Product Change Notification: P-22-023166

MULTIGIG Half size Daughtercard connectors

Description of Changes

TE MULTIGIG shroud, Half size.

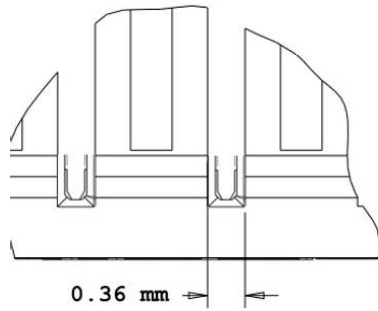
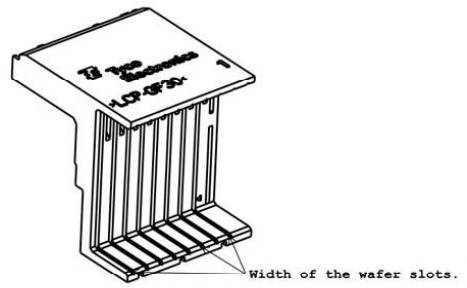
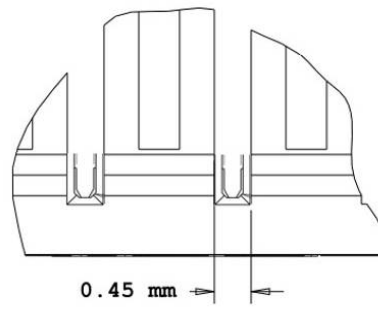
Increase the width of the wafer slots on housing(Shroud) by 0.9mm. See the Images below.
